| Regarding        | Response to Council's comments<br>251-265 Lygon Street and 1A Pitt Street, Brunswick East |
| Reference Number | 18505T-MEMO02-F01                                                                         |

As requested, this memorandum has been prepared to address Council's comments regarding the proposed car parking layout. Following the submission of the s72 application, Council provided comments relating to the car parking design. These comments are reproduced below in **bold italics**, followed by Ratio's response and assessment.

**Column Locations**

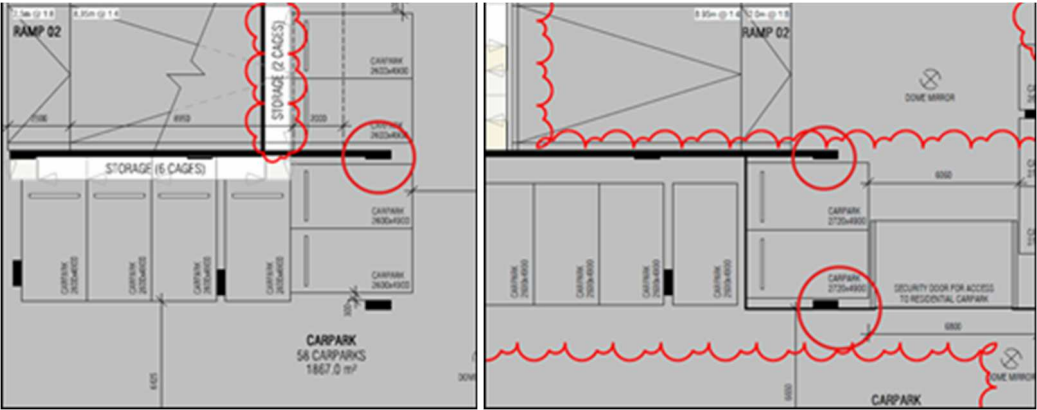
***Diagram 1 of Clause 52.06 of the Planning Scheme requires that columns not be inside the 'Clearance Required' areas of each car parking space. It appears that some of the columns are not meeting this requirement.***

It is acknowledged that the columns adjacent to the car parking spaces identified above do not strictly comply with Diagram 1 of Clause 52.06, which specifies an additional 300mm clearance where a parking space is located adjacent to a vertical obstruction within the clearance envelope, resulting in a total parking space width of 2.9 metres. The purpose of this additional clearance is to provide adequate space for vehicle door opening.

In assessing the functionality of the affected spaces, consideration has been given to the relevant requirements of AS 2890.1. The subject spaces will be allocated to residents of the development and are provided with a minimum overall width of 2.7 metres,

comprising a standard 2.4 metre wide parking bay with an additional 300mm clearance adjacent to the obstruction. As such, the spaces are consistent with the dimensional requirements illustrated in Figure 5.2 of AS 2890.1 and are considered to achieve the underlying objective of providing sufficient door opening clearance and an acceptable level of parking functionality.

Furthermore, as these spaces will be used by residents who will become familiar with the parking layout and operating conditions of the development, the proposed arrangement is expected to operate effectively in practice. Given the location and configuration of these parking spaces, it is recommended that they be designated as "Reverse Parking Only" to facilitate suitable vehicle manoeuvring and accessibility.
